Addendum No. 003

**Subject: Rhawnhurst Elementary School- Additions and Renovations
SDP Contracts No. B-070, B-071, B-072 and B-073 of 2019/20**

**Location: Rhawnhurst Elementary School
7809 Castor Avenue
Philadelphia, Pennsylvania 19152**

This Addendum, dated March 30, 2021 shall modify and become part of the Contract Documents for the work of this project. Any items not mentioned herein, or affected by, shall be performed strictly in accordance with the original documents.

LARGE SCALE TOILET PLANS

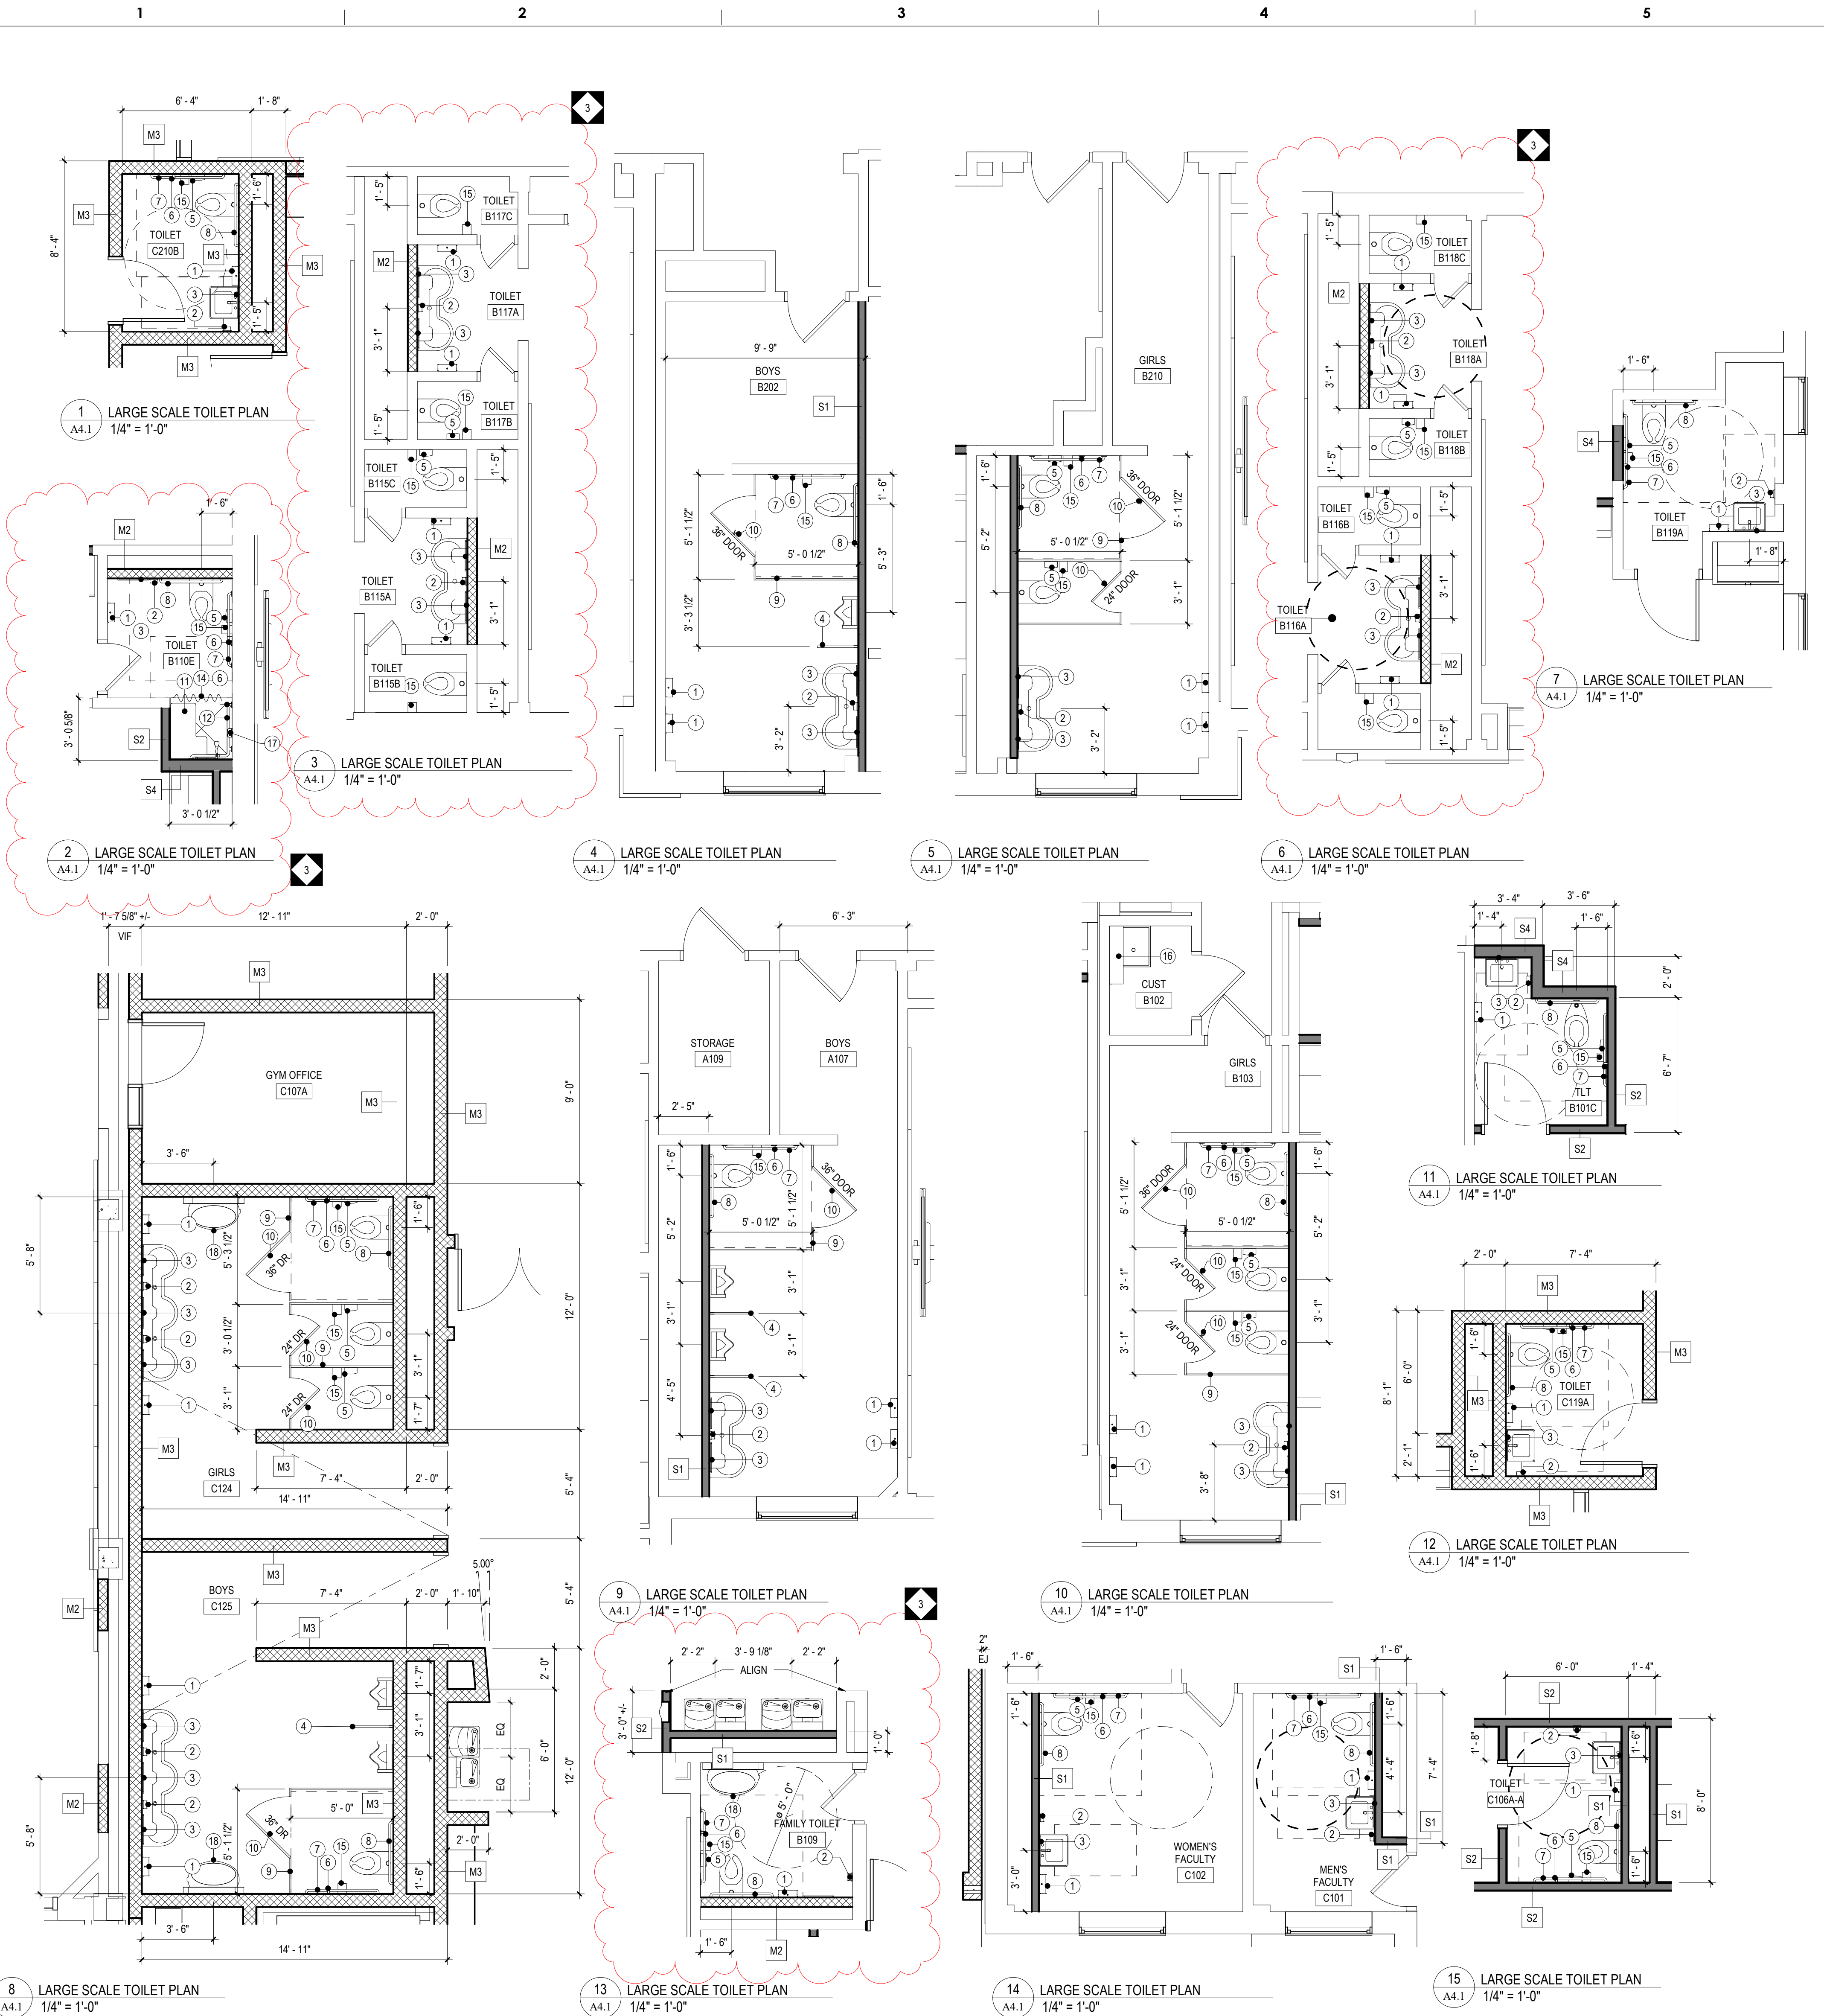
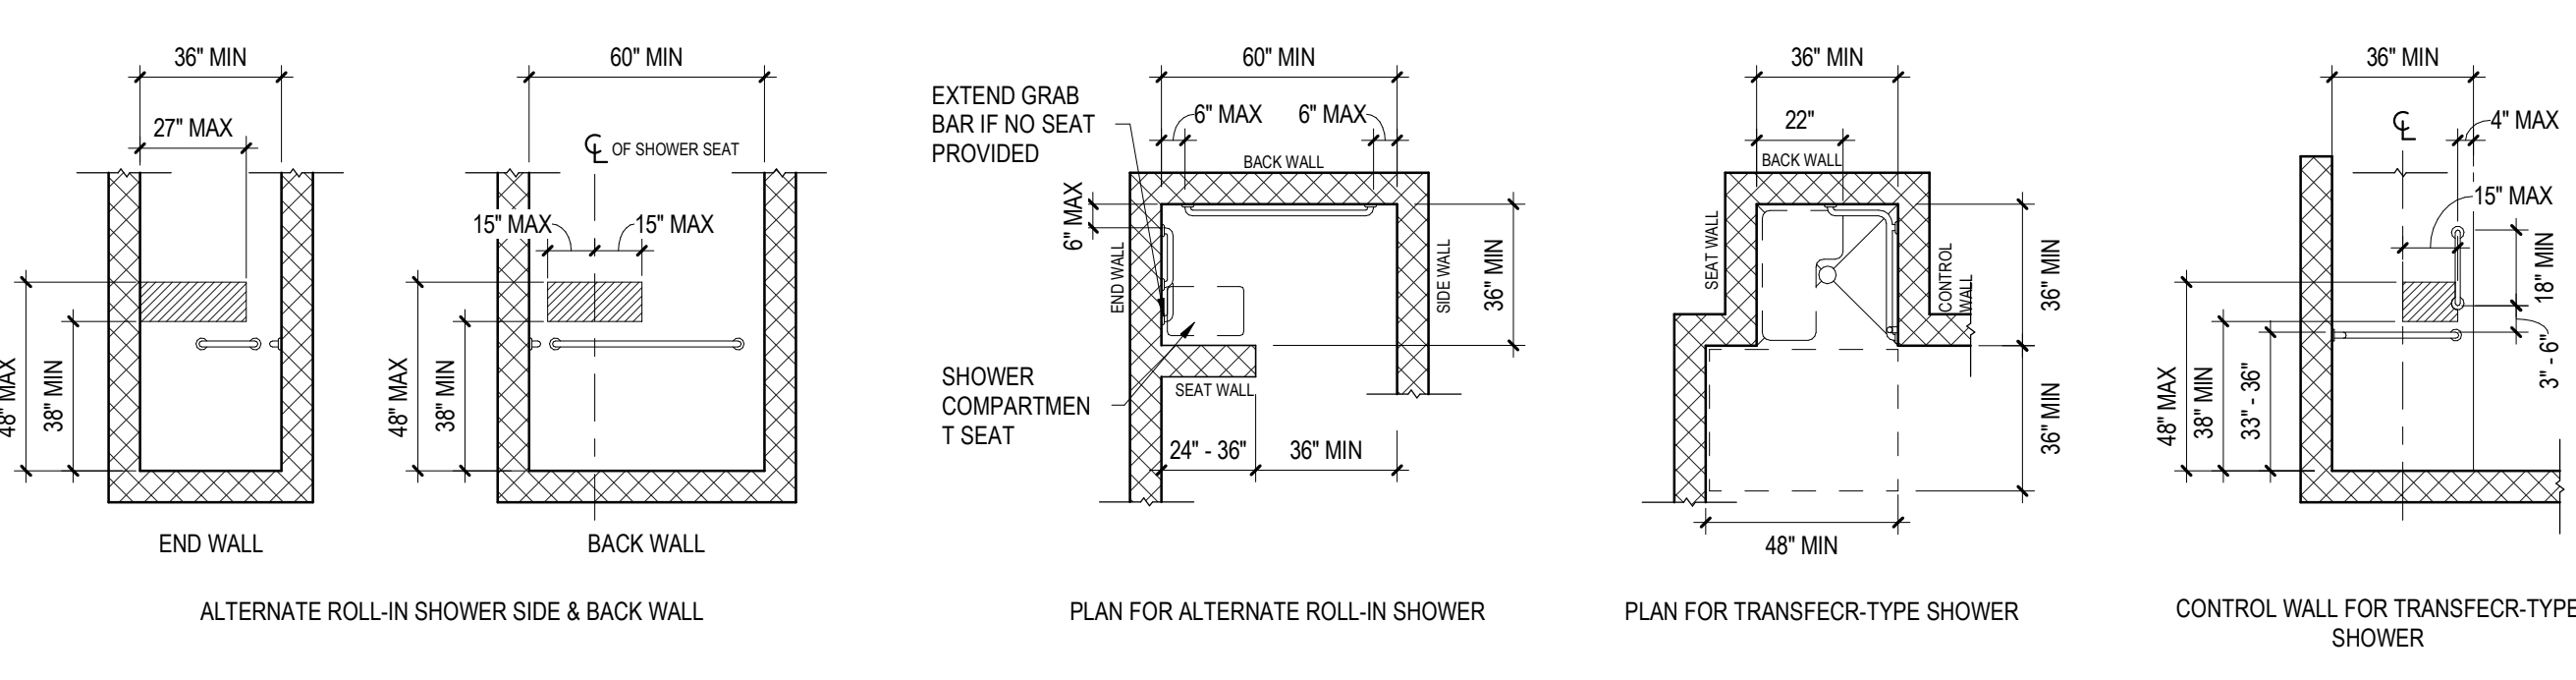
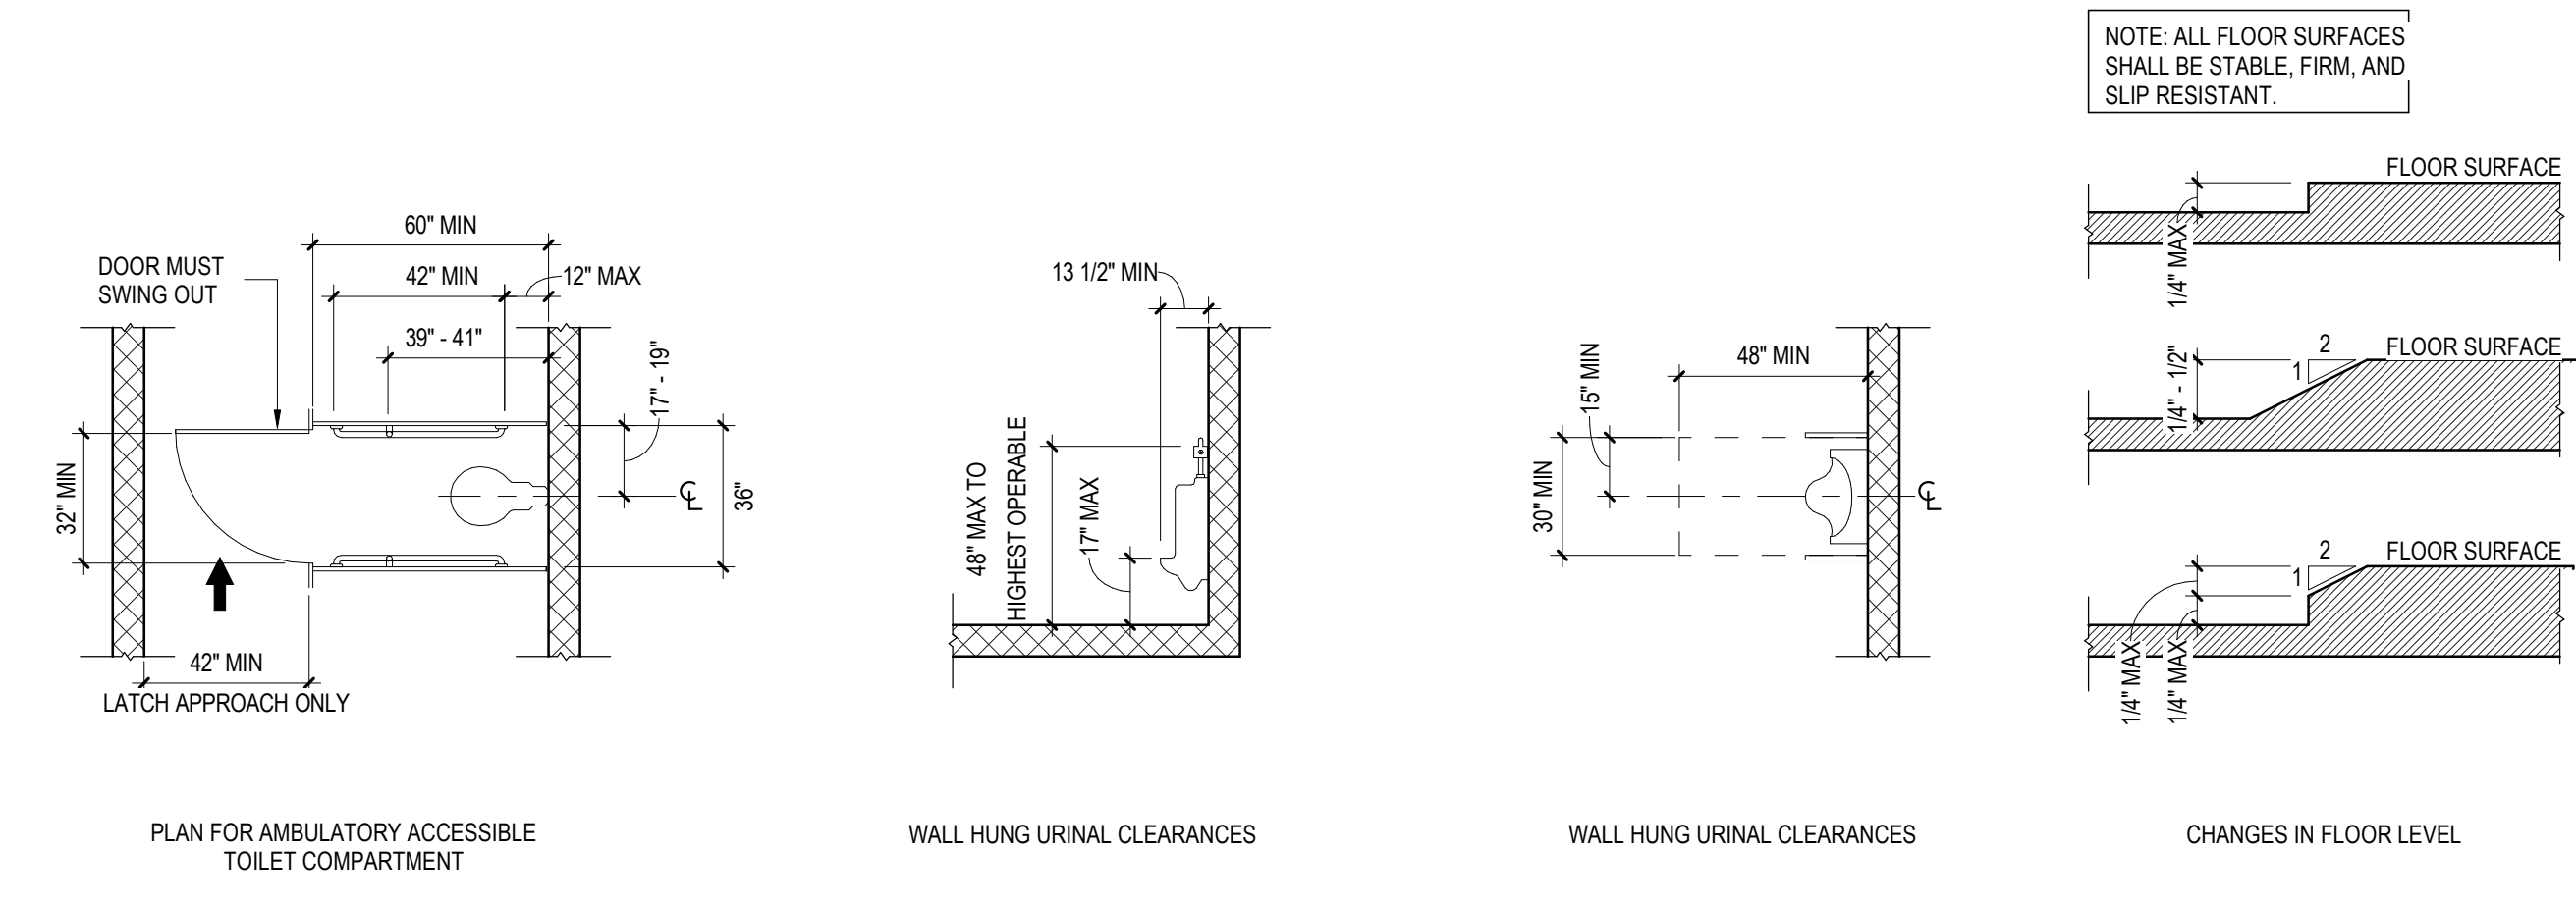
1. **REPLACE** A1.4 AND A4.1 in their entirety as part of Addendum #3. Walls are being demolished and replaced as indicated on the revised drawing to allow for plumbing demolition and replacement in the plumbing chases. These walls include B109, B110E, B115A, B116A, B117A and B118A. General contractor shall coordinate for the new installation of new plumbing and penetrations, sleeves etc. through these walls.
